20 August 2026
BMC26044: 392 Old Cleveland Road, Coorparoo

RE: 392 Old Cleveland Road, Coorparoo
Traffic Engineering Response to Further Advice Letter
Brisbane City Council Reference A006408815

As requested, this advice has been prepared to summarise a traffic engineering review of the site access for 392 Old Cleveland Road, Coorparoo and assist in responding to Brisbane City Council's Further Advice letter dated 3 October 2025. Specifically this advice addresses Items 1 – 3 of the Further Advice letter, with those Items reproduced and responded to directly below.

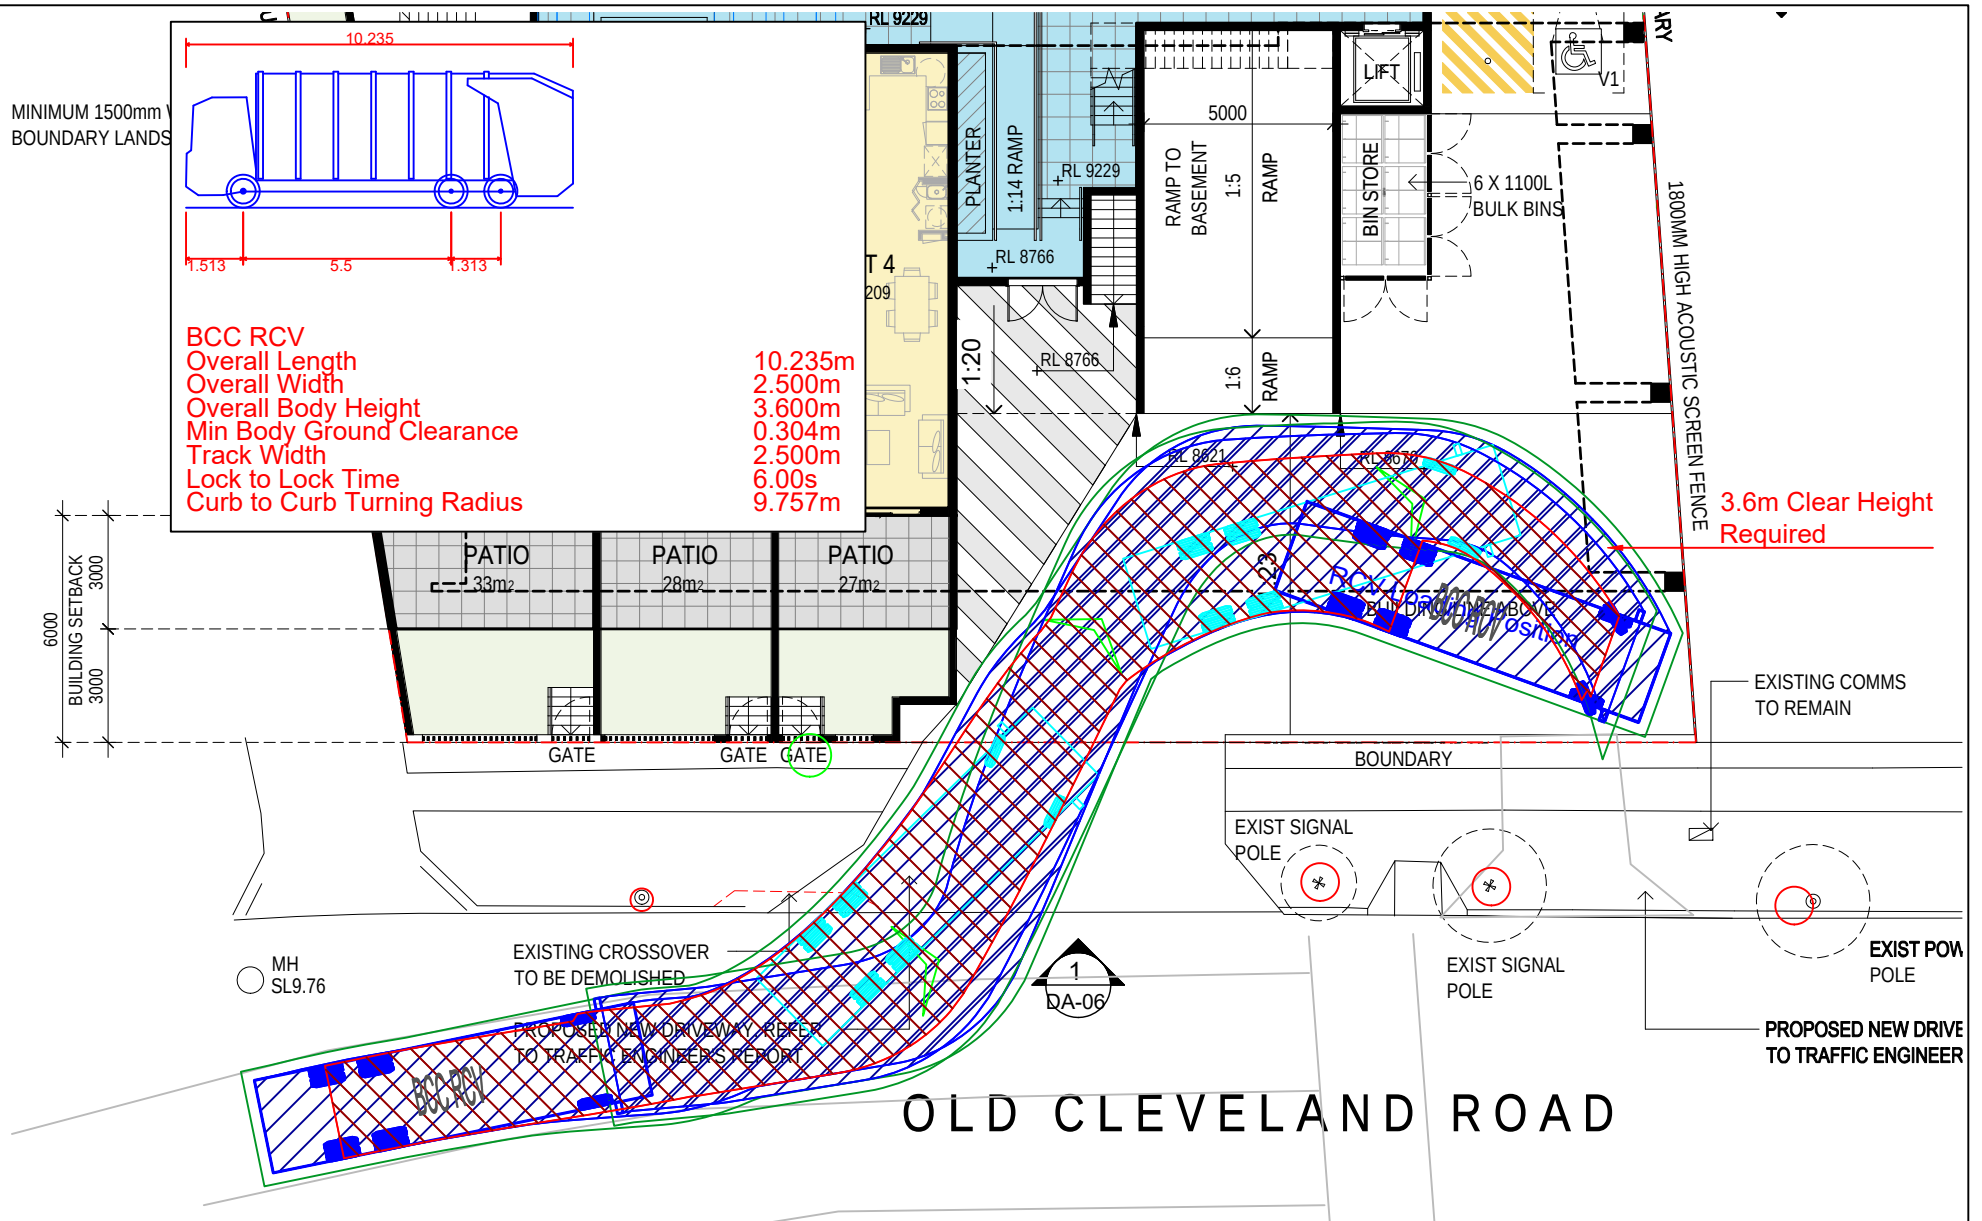
The supplied refuse collection vehicle (RCV) swept path analysis, drawing number 25GCT0089-01 Revision A, has not utilised a lock-to-lock time of six seconds in accordance with Table 5.1 of the Australian Standard ASW2890.2:2018. To ensure safe and efficient RCV manoeuvring and to ensure that the proposed development complies with AO1, AO19.2 and AO19.3 of the Transport, access, parking and servicing code, provide amended swept path drawings.

- a) *Submit a Registered Professional Engineer of Queensland (RPEQ) certified, signed and scaled rear loading RCV swept path assessment that utilises a lock-to-lock time of six seconds and that is free of conflicts when applying a 500mm clearance envelope.*

Swept path assessments have been undertaken for the 10.235m long RCV defined by BCC's Standard Drawing BSD-3008, with the results provided at Attachment B to this advice. These swept paths include a 300mm clearance line, which meets the requirements of Section 5.4(a) of Australian Standard for Off Street Car Parking AS/NZS2890.2:2002 for low speed manoeuvres. Of note, typically clearance over and above the indicated 300mm clearance line is demonstrated.

The swept path assessments show:

1. The RCV driving forward onto the site and loading in a position clear maintaining accessibility of the basement ramp.
2. The RCV reversing into an area recommended to be dedicated for that purpose, e.g. to be clearly labelled 'No Parking', prior to undertaking a forward exit movement from the site.
3. All reversing is contained within the site.
4. The wheels of the RCV are contained within the proposed crossover on entry and exit.

B99 Ramp Access / RCV Loading

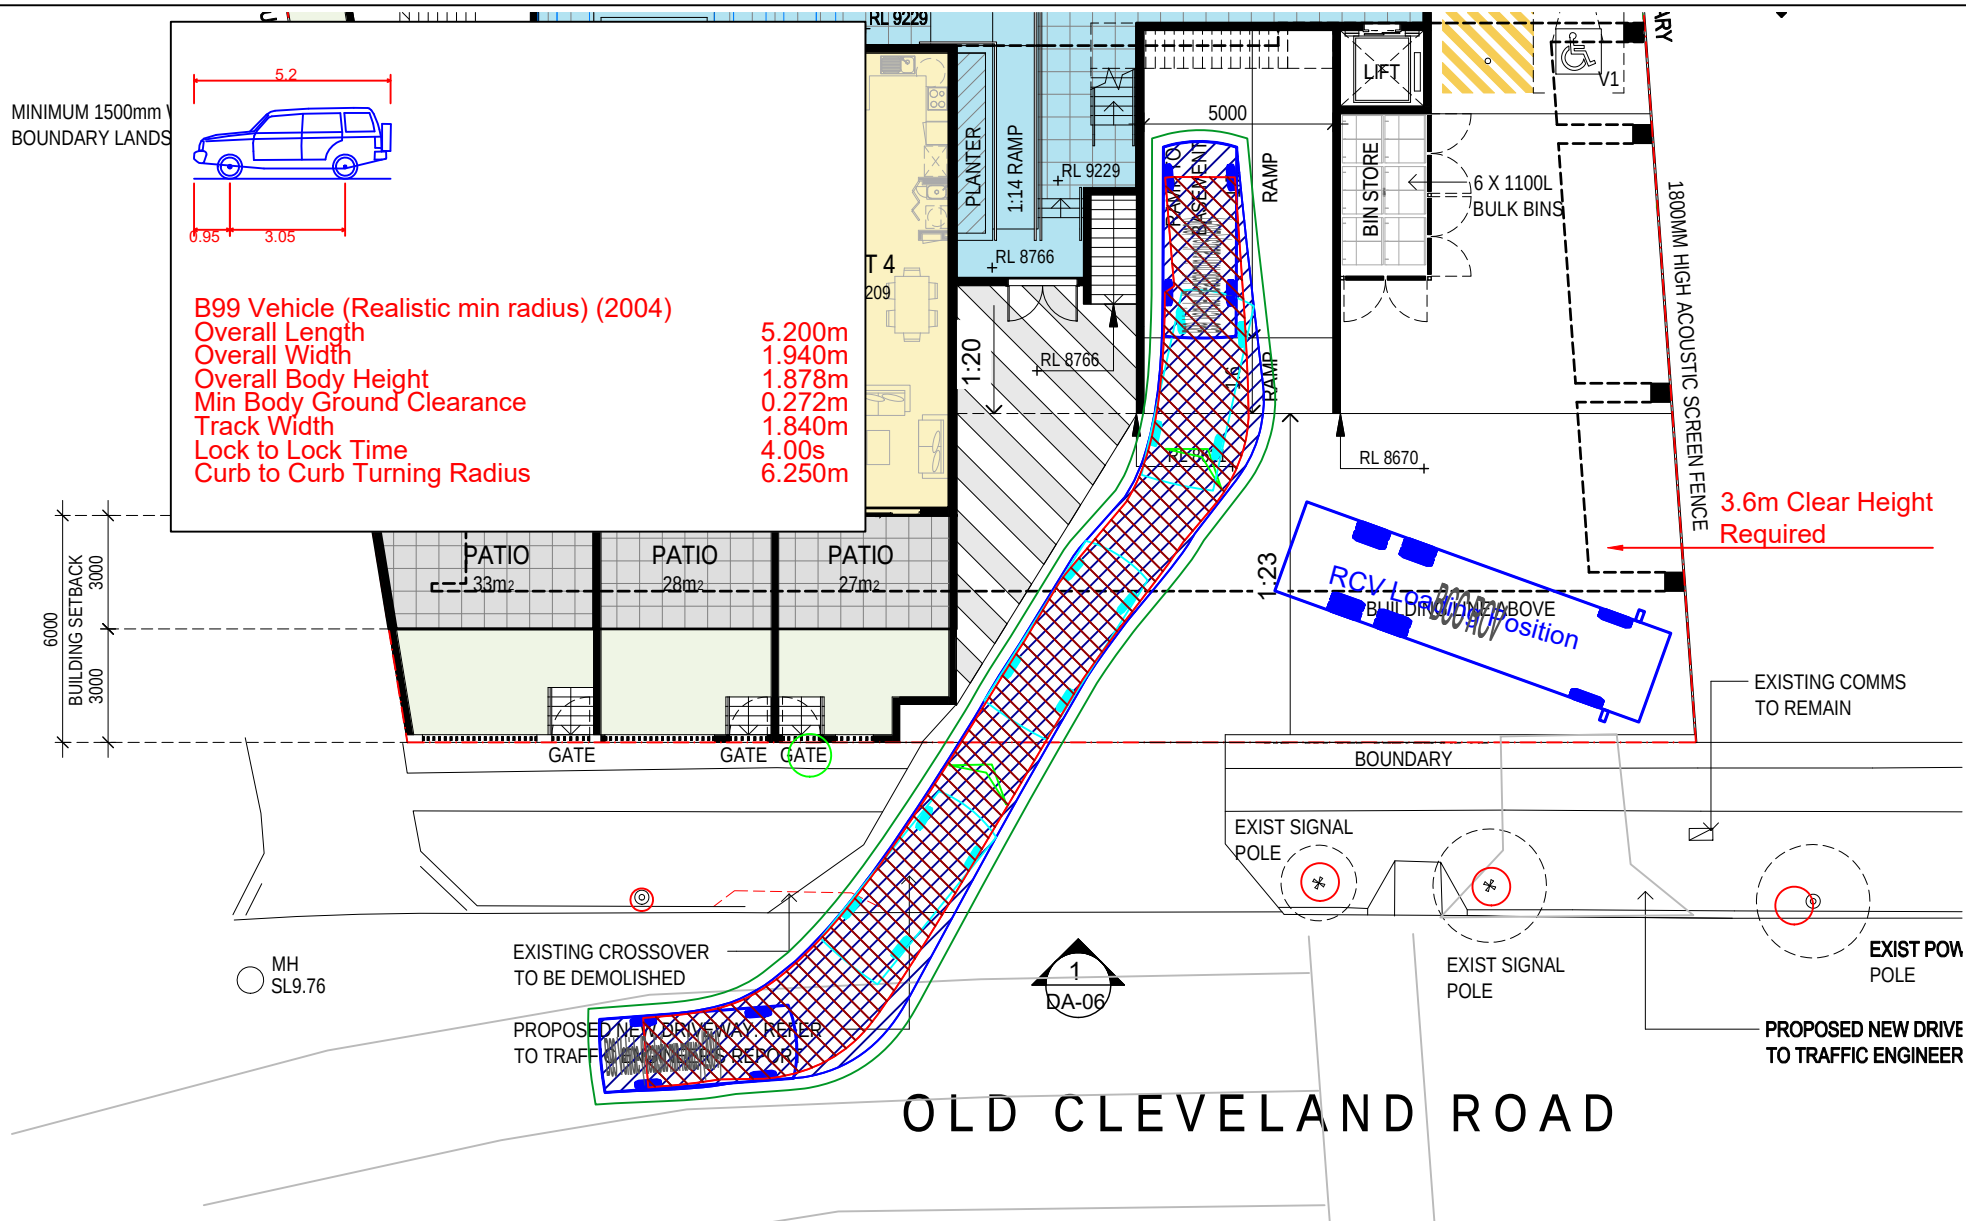
The site layout, on-site servicing arrangements and vehicle swept paths are to be redesigned to suit the above-mentioned single crossover located as far west as practicable along the site frontage, in compliance with PO1, PO15, PO18 and PO19 of the Transport, access, parking and servicing code and PO8 of the Infrastructure design code.

PO18 TAPS Code Development is serviced by an adequate number and size of service vehicles.	The updated plan at Attachment A enables a 10.235m long Refuse Collection Vehicle to load from a position which: 1. Does not block access of the ramp to the basement car parking. 2. Does not require the driver to cross the ramp to service the bins. 3. Enables forward in / forward out access of the RCV. This is subject to maintaining a minimum 3.6m height clearance in the refuse collection vehicle access areas.
PO19 TAPS Code. Development layout provides for services which: a. are wholly within the site, other than service vehicle manoeuvring areas which may overhang the verge on a minor road where use of the footpath is not adversely affected; b. are clearly defined, safe and easily accessible; c. are designed to contain potential adverse impacts of servicing within the site; d. do not detract from the aesthetics or amenity of the surrounding area.	The changes included at Attachment A enable a 10.235m long Refuse Collection Vehicle to load from a position which is fully within the site.
